# Silicon Anomaly Sheet

AD1835

This document details known bugs in the current version of the AD1835.

Figure 4. Reset Synchronized to Rising Edge of FSTDM/ALRCLK

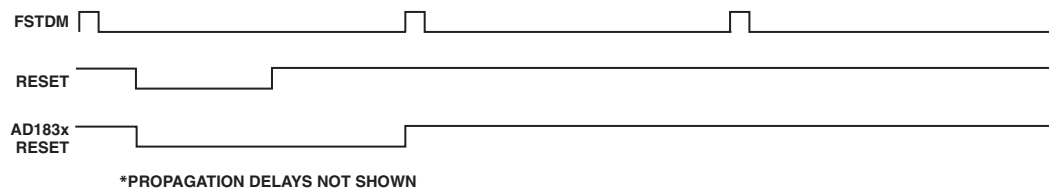
The ADC engine used in the AD1835 loads the serial port with the results of the last conversion periodically at the sample rate. The loading operation is initially determined by where the  $\overline{PD/RST}$  pin goes high. For slave mode operation, the loading operation and LRCLK or FSTDM signal have no fixed relationship so it is possible that the loading operation can occur in the middle of a data transfer. This results in the right ADC sample being one sample ahead of the left ADC sample, which presents itself as a phase shift. See Figure 1.

Synchronizing the rising edge of  $\overline{PD/RST}$  with the appropriate LRCLK (for I<sup>2</sup>S, left or right justified modes) or FSTDM (for TDM256 mode) edge will ensure that the ADC result updates occur in a safe region and the phase shift will not occur. Figure 2 shows a synchronization circuit using a single flip-flop that latches the reset signal on the rising edge of FSTDM/ALRCLK. Figure 3 shows an alternate circuit for latching the reset on the falling edge of ALRCLK. Figure 4 shows a timing diagram associated with Figure 2. Table I lists the ADC modes affected by this issue and which circuit should be used to prevent it occurring.
